TEXAS COMMISSION ON ENVIRONMENTAL QUALITY

NAME OF PROJECT: Gruene River Resort and Recreation Center; Located at 1554 Gruene Road; New Braunfels, Texas

TYPE OF PLAN: Request for Modification of an Approved Water Pollution Abatement Plan (WPAP); 30 Texas Administrative Code (TAC) Chapter 213 Edwards Aquifer

RE: Gruene River Resort and Recreation Center WPAP Modification Comment Corrections

SITE PLAN

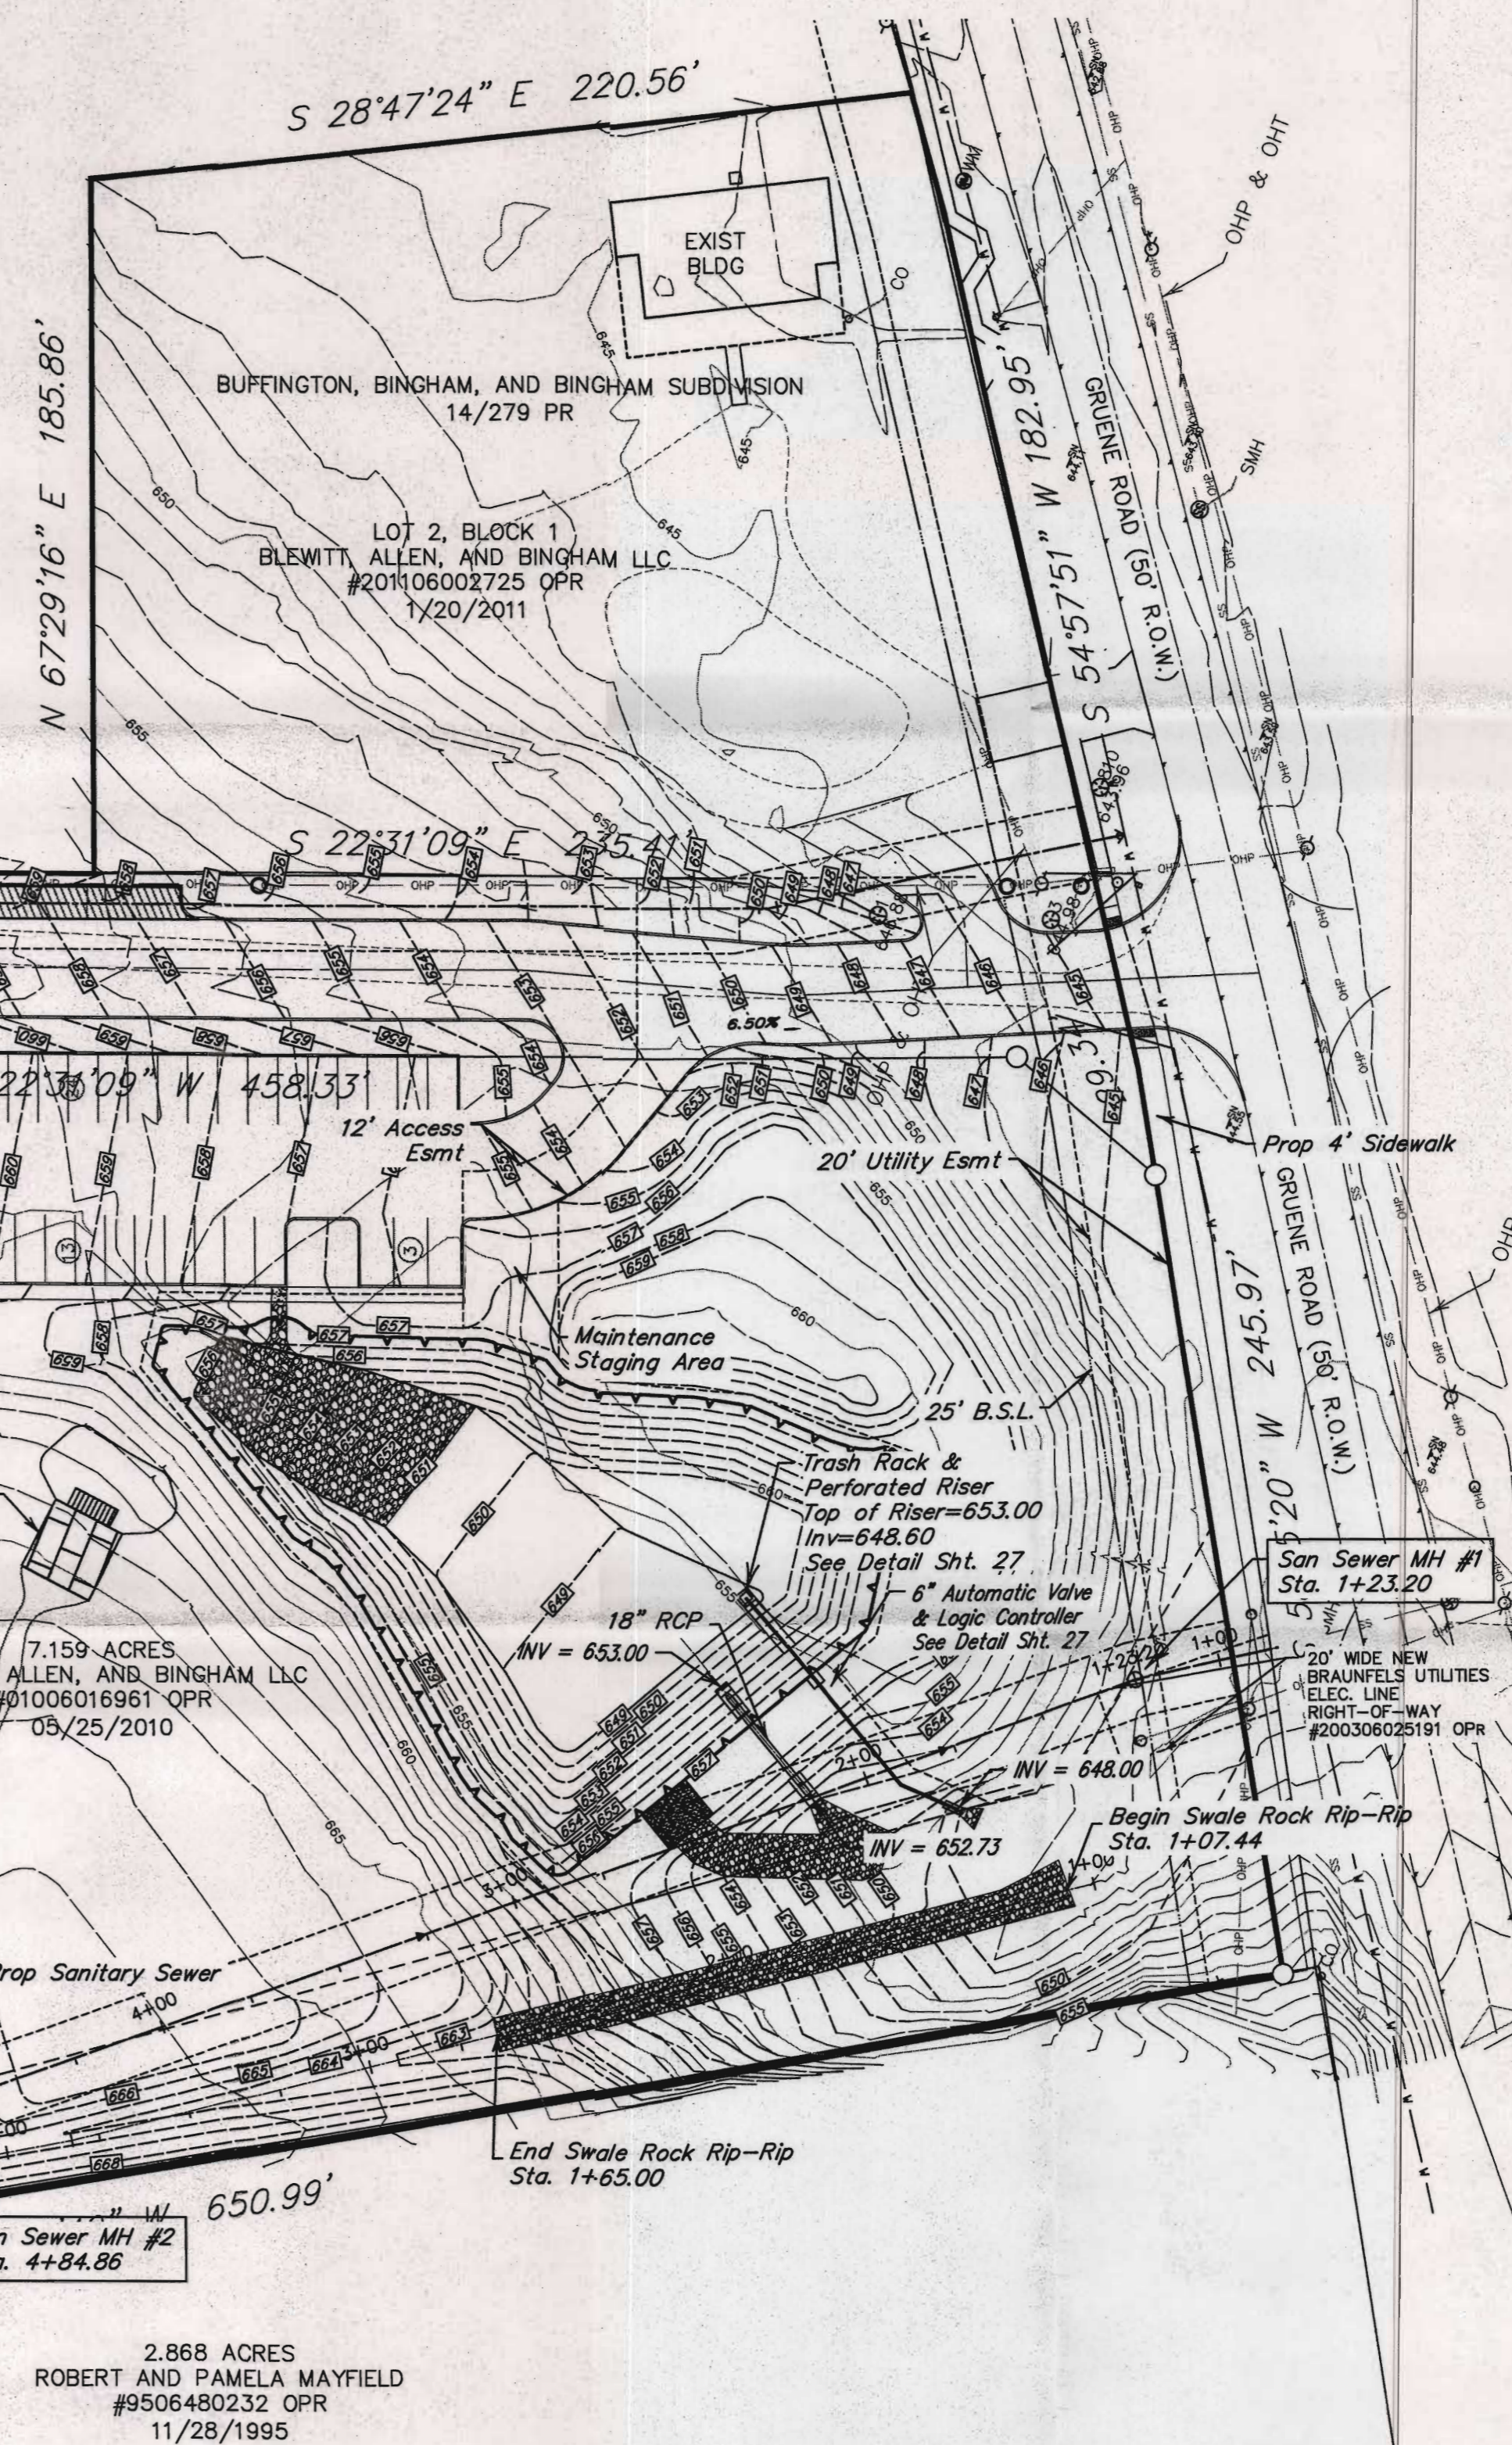
1. The Project Description only mentions that the modification will add impervious cover to the original plan. Please update the project description to specify what impervious cover is being added to the site. In addition, please update the site plan to highlight or mark the additional impervious cover.

The project description was updated specifying what impervious cover has been added. The site plan has been updated with callouts for added impervious cover.

TSS Removal by Drainage Area

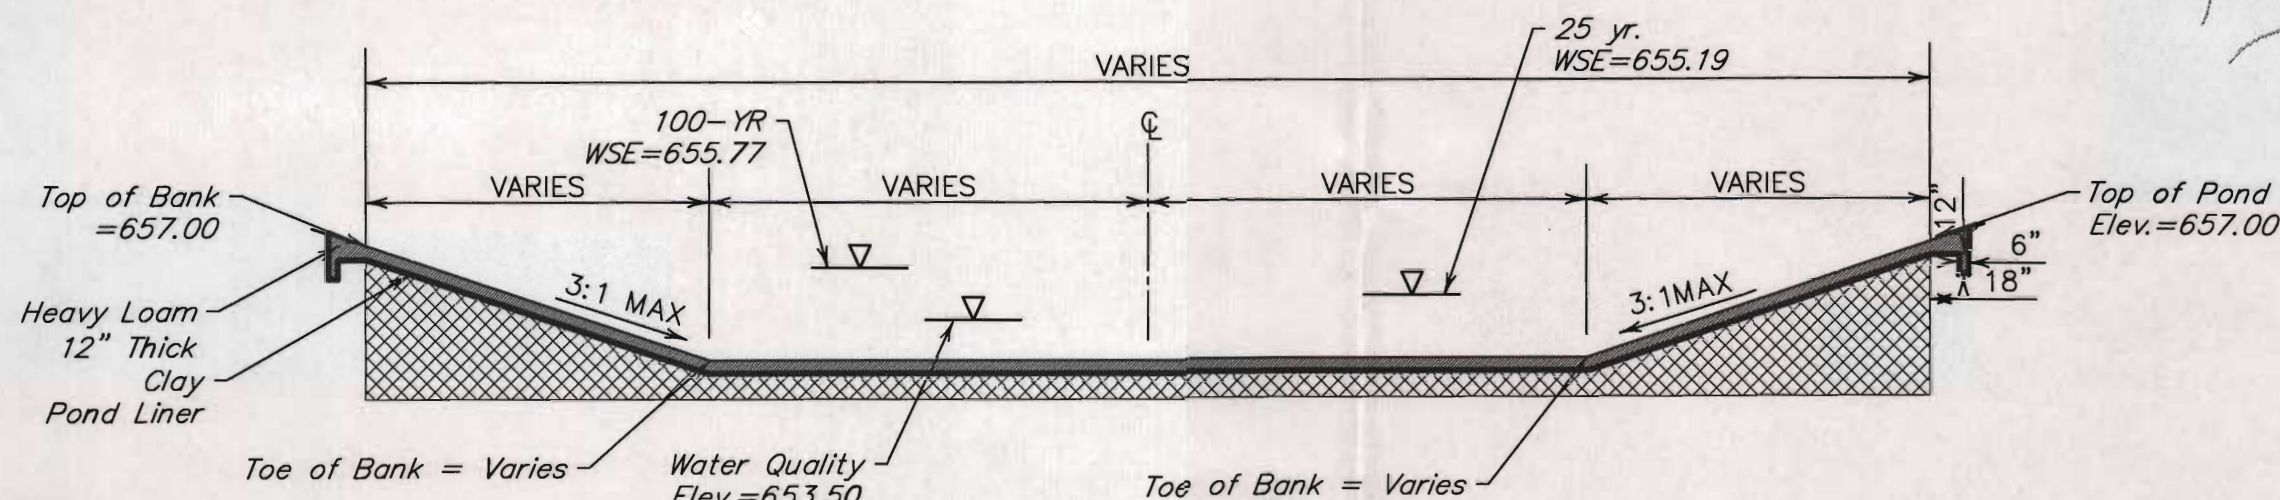
I was reviewing the submitted amended materials for the subject WPAP modification and noted that the Drainage Areas do not add up correctly on the TSS Removal by Drainage Area chart provided.

Area from drainage 2 and 3 was added to area 1 to capture the increased impervious cover within the pond. The areas that were added to drainage area 1 were not removed from drainage areas 2 and 3 in the summary table. I have attached the updated summary table reflecting this.
